A-12 REFLECTED CLG. PLAN - FIRST FLOOR SHERIFF'S
REVISIONS TO S1000, S1002, S1003

ADDENDUM NO.2		7/10/90
KENTON PETERS + ASSOC. 44 E. MIFFLIN MADISON, WISCONSIN 53703 (608) 255-5858	JEFFERSON COUNTY LAW ENFORCEMENT CENTER JEFFERSON, WISCONSIN	EA-1

FIRST FLOOR PLAN
3/8"=1'-0"
LIGHTING

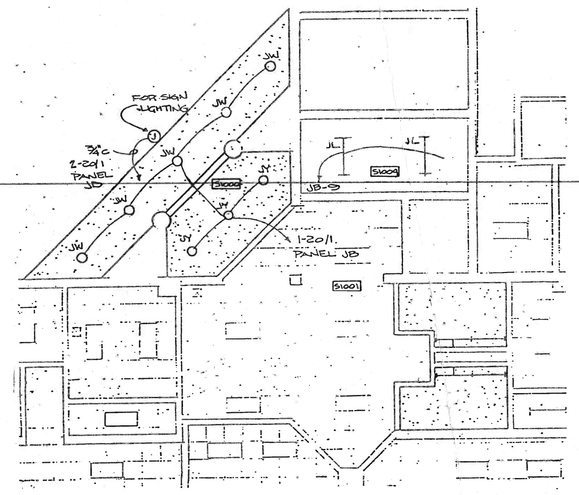
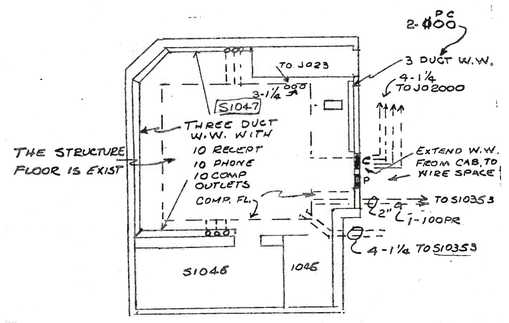
RM 2000 IS MECH. SPACE ABOVE KITCHEN PROVIDE SLEEVES AT NE. & S.E. CORNER FOR RADIO MICROWAVE. 1¼" SLEEVES.

1. J1000 - Delete 2 'JR' fixtures. Install 3 'JY' fixtures in Room J1000.
2. Install 5 'JW' fixtures in canopy outside Room J1000.
3. Install junction box in canopy for sign lighting. Provide 2 20/1 circuits from panel 'JB'.
4. S1004 - Delete 2 'JS' fixtures. Provide 2 'JL' fixtures. See Sheet ER-1.
5. S1015 - Provide 1 'JP' fixture over sink and water closet. Delete 1 'JM' fixture at East end of room. 'JM' fixture at West end of room to remain.
6. Control pod - delete to 'JH' fixtures. Install 2 'JS' fixtures. See reflected ceiling plan.
7. S1026-1 - Delete 2 'JL' fixtures. Install 2 'JG' fixtures.
8. Add one (1) 'JE' fixture in each of 4 cell block vestibules. Lights to be controlled individually from "Pod Control Center".
9. Add six (6) 'JL' fixtures in generator room. Add switch and receptacle at door.

Exit light: south side of door S1004-B and south side of door S1060-B

NOTE: Exit lights above doors S1004-B and S1060-B hooked up to panel JB
